PROPOSED CHANGES TO THE GALAXY LITHIUM (CANADA) INC.
LITHIUM MINE PROJECT

NOTICE TO THE IMPACT ASSESSMENT AGENCY OF CANADA

ENV1007-1504-01_EN

May 6, 2025

Figure 3-2. Direct unloading of mine trucks at the primary crusher

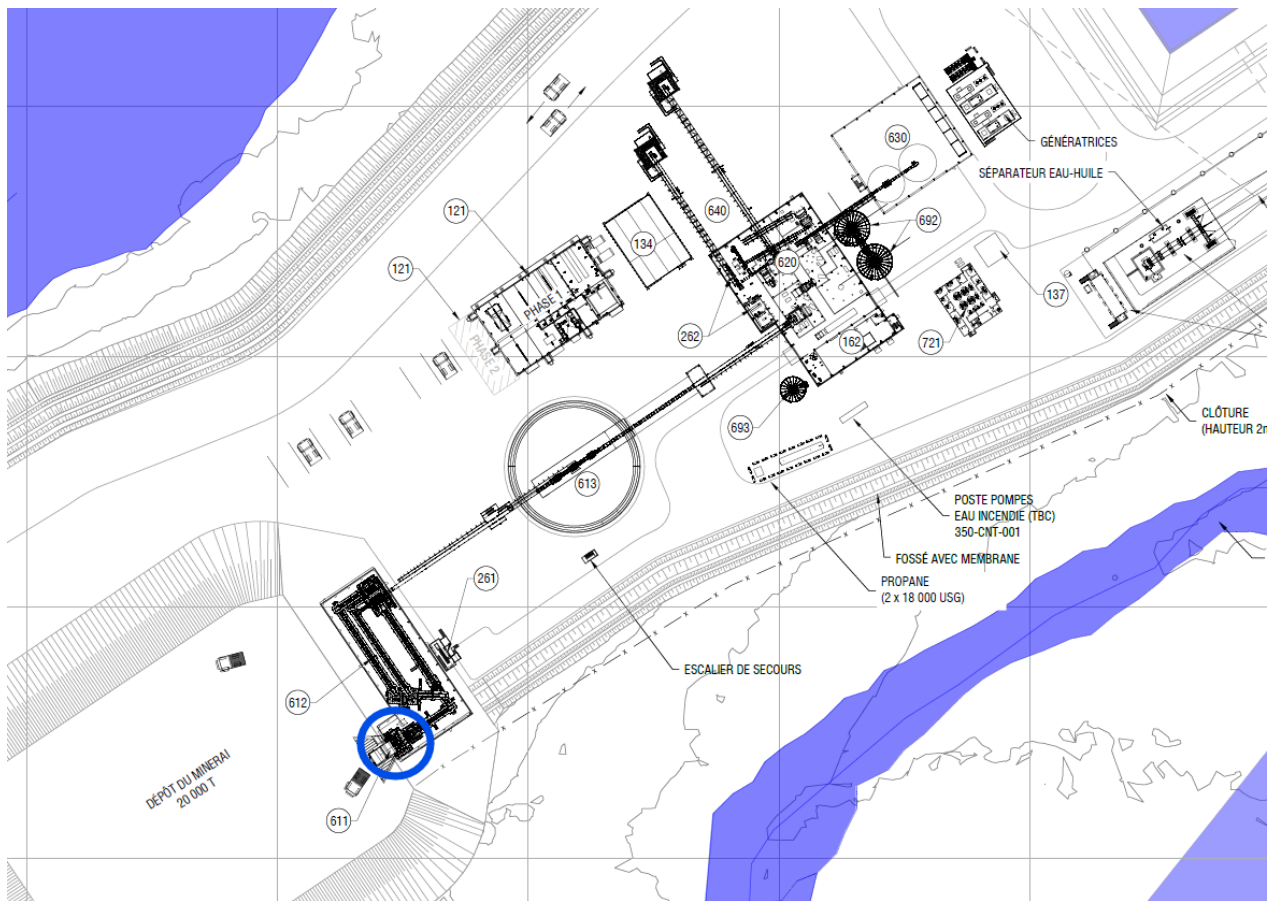
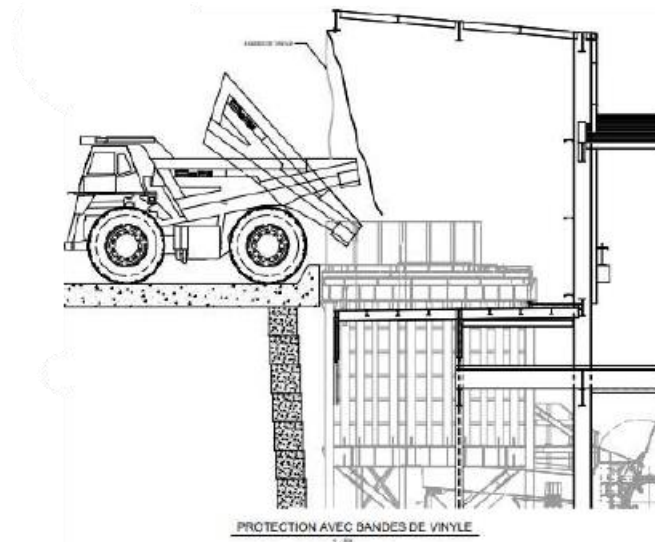
This change relates to the ore feed mode of the primary crusher. The location of the primary crusher is illustrated in Figure 3-1 and the site’s general layout plan is found in Appendix B.

As initially planned and authorized, the ore extracted from the pit was to be transported by mine trucks to the temporary ore pile. From there, a front-end loader would transfer the ore to the static sieve of the primary crusher.

To improve operational efficiency, it is now proposed to feed the primary crusher directly with trucks, eliminating the intermediate stockpiling step (Figure 3-2). This change would remove the continual use of a front-end loader, thereby reducing diesel consumption and lowering health and safety risks associated with equipment interactions in the temporary storage areas.

In addition, to limit dust emissions during truck unloading at the crusher, water will be sprayed onto the static sieve when weather conditions allow. A vinyl strip curtain will also be installed at the entrance of the unloading zone. This curtain will help contain any dust emissions that could be generated during unloading.

Figure 4-1. Location of the buildings heated with propane gas and location of the tank

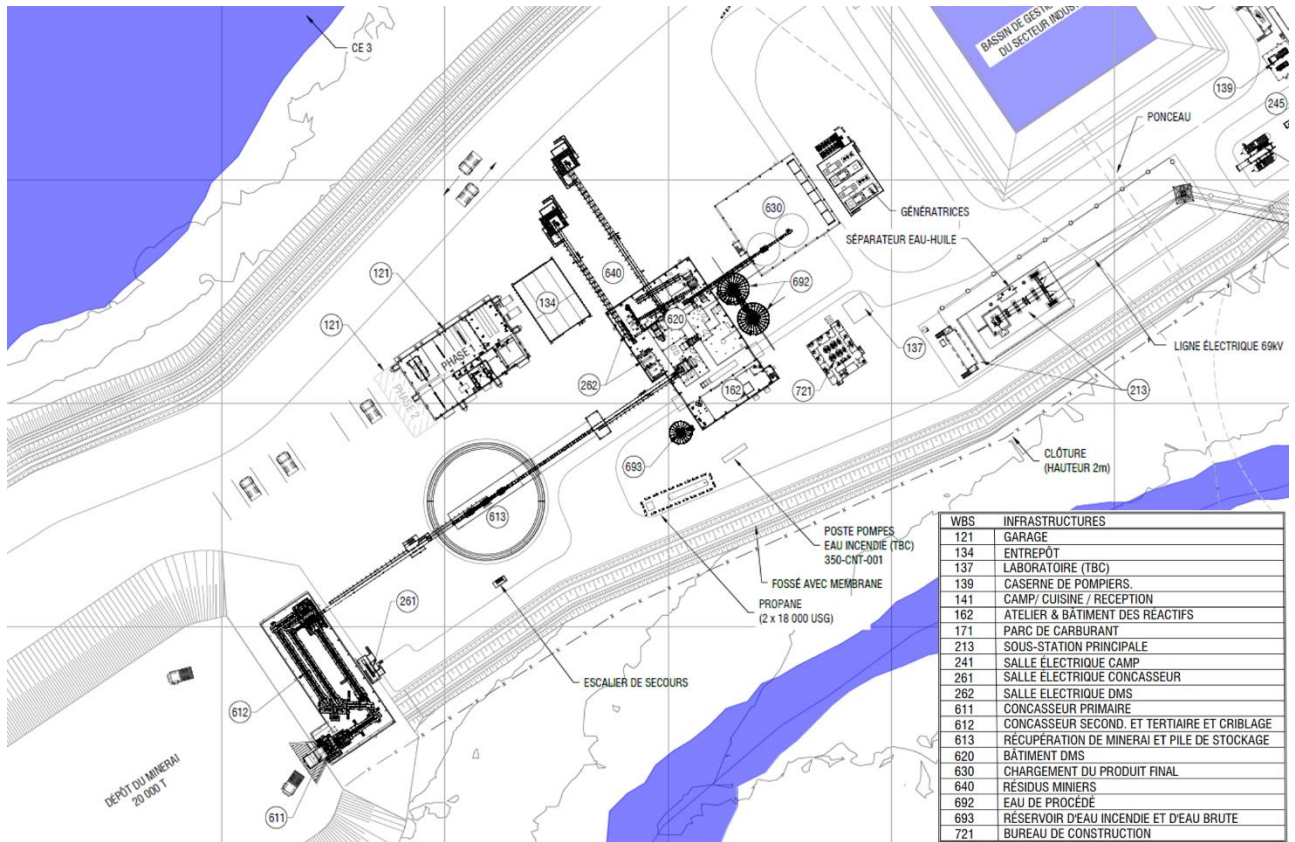
This change concerns the design update of the heating and ventilation system of the treatment plant and the industrial sector buildings. Initially, each building had its own auxiliary heating unit. It is now proposed to replace the initially planned electric unit heaters with the addition of two propane boilers (located in the plant building (DMS)), which will supply glycol water loop heating to five buildings in the plant area: The workshop and reagents area (162), the DMS building (620), the warehouse (134), the truck shop (121) and the concentrate building (630). Local heating of the crushing building will also be provided using propane unit heaters. Heat recovery from the generators is also planned as part of the glycol water loop design.

Each of the boilers (Cleaver Brooks CFLC-700-8000 models) has 8,000 MBH (2,344 kW) of power, for a total of 4,688 kW.

Figure 4-1 illustrates the location of the buildings concerned by the change (refer to the number in parentheses corresponding to each building). The general layout plan is available in Appendix B.

Moreover, to limit air emissions, GLCI is committed to a minimal use of heating, by only maintaining the temperatures necessary for operation of the machines and storage of chemicals.

Figure 5-4. Silos and closed conveyors, new concept

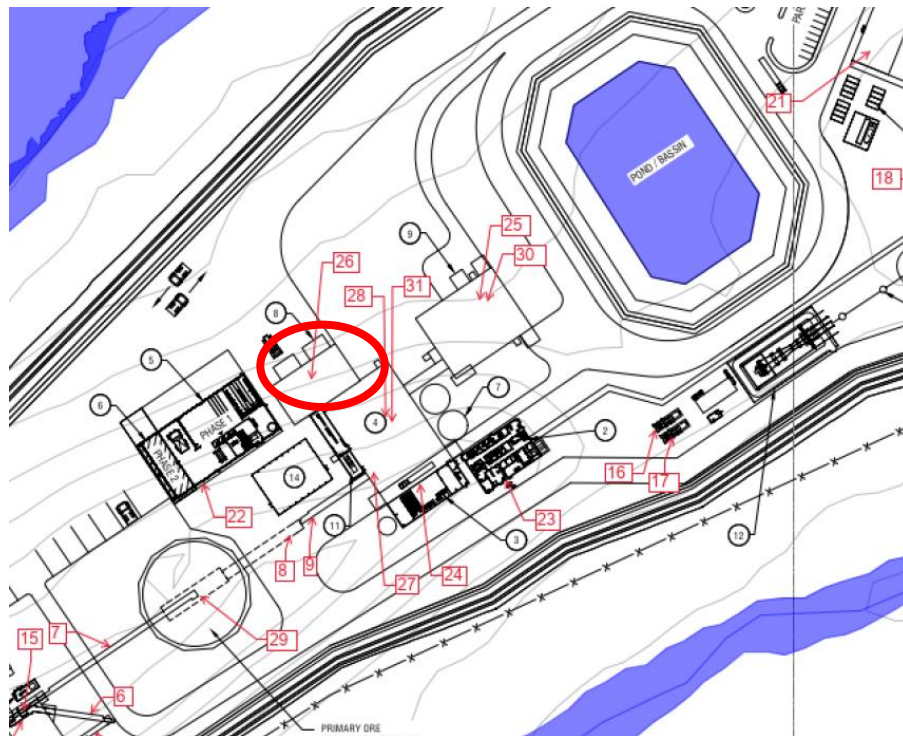
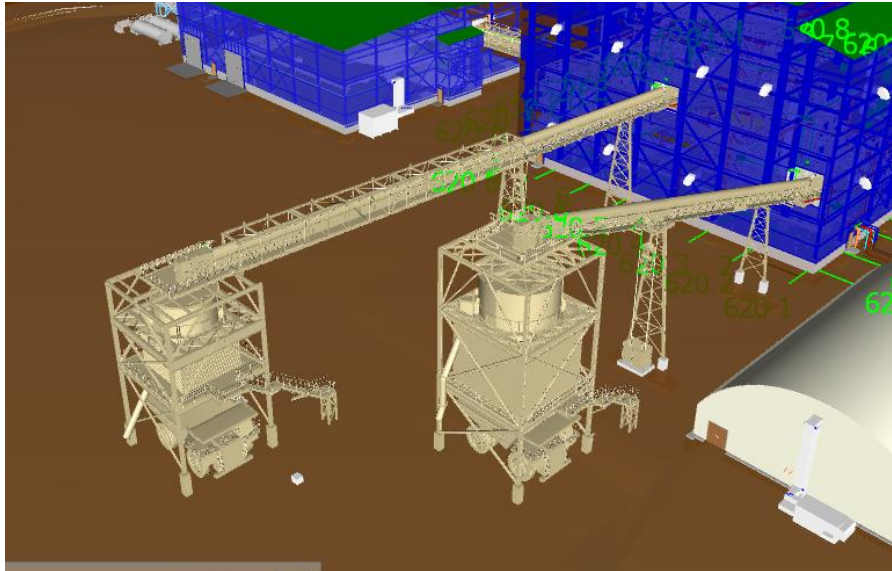
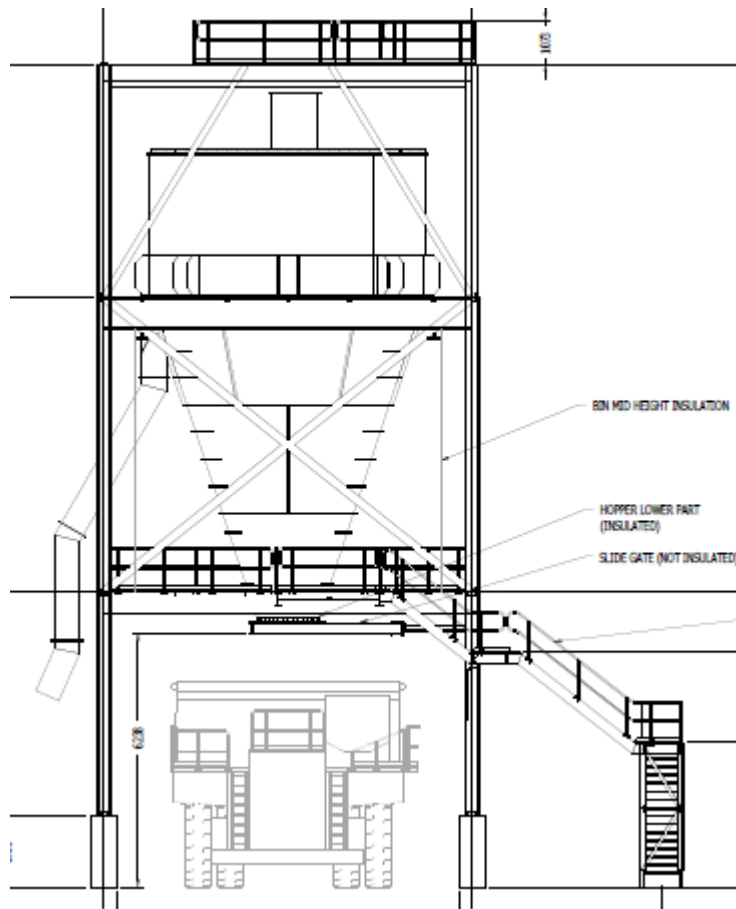
This change concerns the tailings loading step in the trucks at the ore processing plant exit. The initial and authorized concept planned to load the tailings in the haulage trucks inside a dedicated building (Figures 5-1 and 5-2). It was planned to pile the fine and coarse tailings in two separate piles in the building and to fill the haulage trucks by continual shuttling of two front-end loaders.

The concept was improved to get around a major safety issue during winter operations, in view of the risk of ice formation on the piles (due to the moisture present in the tailings). Because of this fact, it is planned to replace the building dedicated to tailings storage with two (2) silos (one for coarse tailings and one for fine tailings) located outside the plant and connected to it by closed conveyors (Figures 5-3 and 5-4). Therefore, the tailings will be transported to the silos via the covered conveyors, and the haulage trucks will be loaded by means of hoppers with valves below each silo (Figure 5-5). This change reduces the use of diesel equipment and minimizes human handling.

Figure 6-2. General layout of the mobile concrete plant

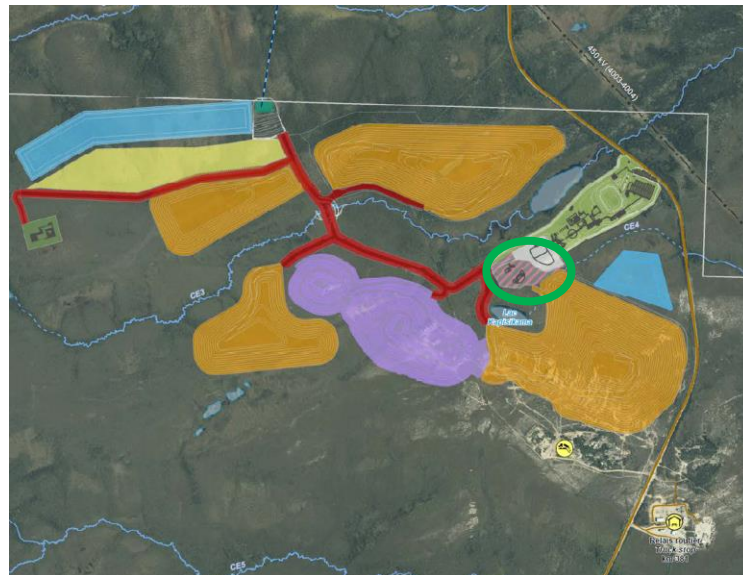
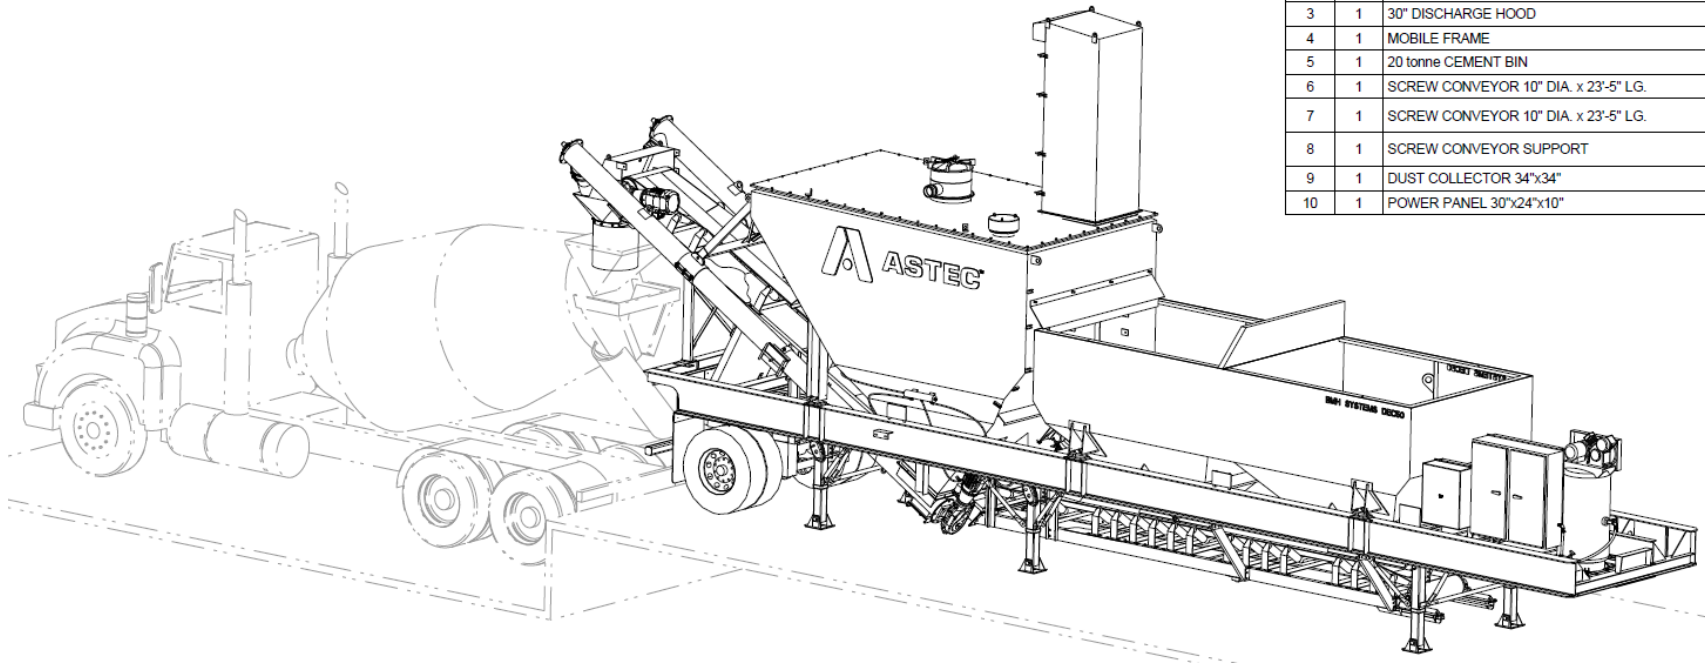
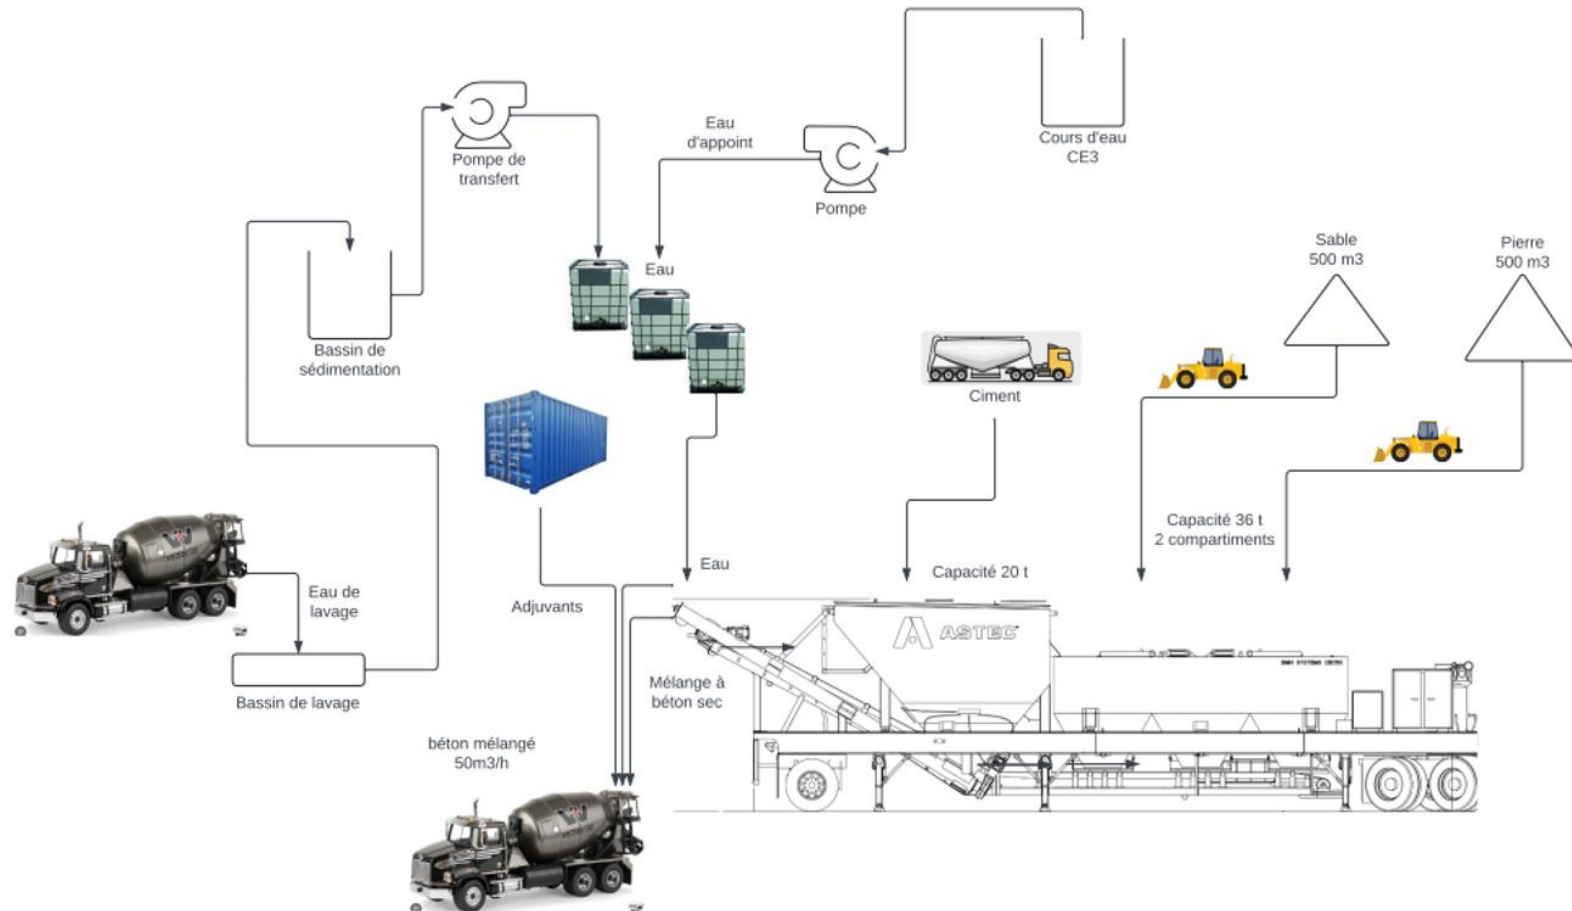
In the context of the project as initially proposed and authorized, a concrete plant was planned for the construction phase and had to be erected southwest of the plant (Figure 6-1). The initial concept as a “wet” plant, meaning that the concrete at the output of the concrete plant was in wet form.

The new concept, a dry concrete plant (BMH Systems DEC50), is mobile (Figure 6-2). The layout of the equipment and the storage zones is illustrated in Appendix D. The dry ingredients, particularly the aggregates, are combined directly in the plant, while water is added subsequently in the concrete mixers. This process allows great flexibility and ensures efficient production reaching up to 50 m³ of concrete per hour. In comparison with the initial concept, this concept allows maximization of the quantity of prefabricated cement (coming from outside the mine site and delivered by semi-trailer).

The plant’s location will be the same as initially. However, the plant’s water supply source is changed; the water will be captured first in watercourse CE3, while Kapisikama Lake will be used as a secondary source, in the event of a low water level in CE3.

Figure 6-3 shows the operational configuration of the facilities. The technical information about the plant and its integrated dust collector is found in Appendix E.

To limit cement particulate emissions, the concrete plant will be equipped with a filter dust collector. Designed specifically for this plant, the dust collector is directly connected to the cement bucket by seal-tight lines, allowing efficient capture of the emissions generated during dry mixing. Its main objective is to reduce dust dispersion significantly during this operation. The guaranteed minimum efficiency of the dust collector is 99.9%. An air and sound emissions monitoring system will be in place to comply with the applicable standards. Regular inspections of the dust collector and the control systems will be conducted in accordance with the manufacturer's recommendations.

To limit dust dispersion from the material piles (sand and aggregates), they will be watered, when required.

The diesel generator that will supply the plant will be equipped with a retention basin to prevent leaks and spills.
